Service Information

CORRECTION TO SERVICE MANUAL

DVD MODULE

DVD MAIN BOARD - TOP VIEW

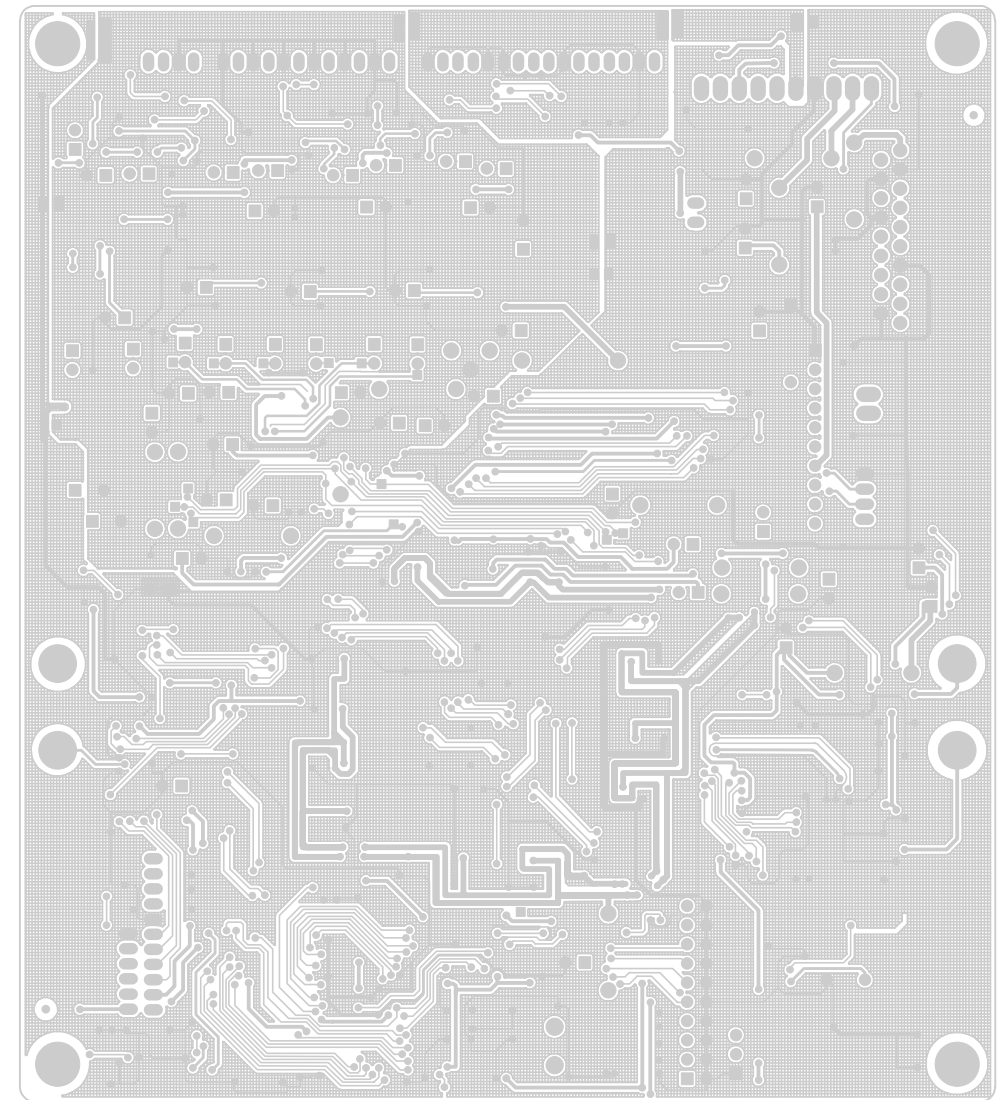
* During production (around wk150) a new DVD Main Board is introduced due to introduction of IC STi5519 which replaces IC STi5505. Due to this modification the following changes must take place simultaneously:

The new DVD Main Board can be recognized by the print mark "55-5938014-10-02" on the board.

- a) New Instruction For Use 9965 000 12051
- b) Front Board's uProcessor U5 9965 000 12047
- c) DVD Main Board (STi5519) 9965 000 12052
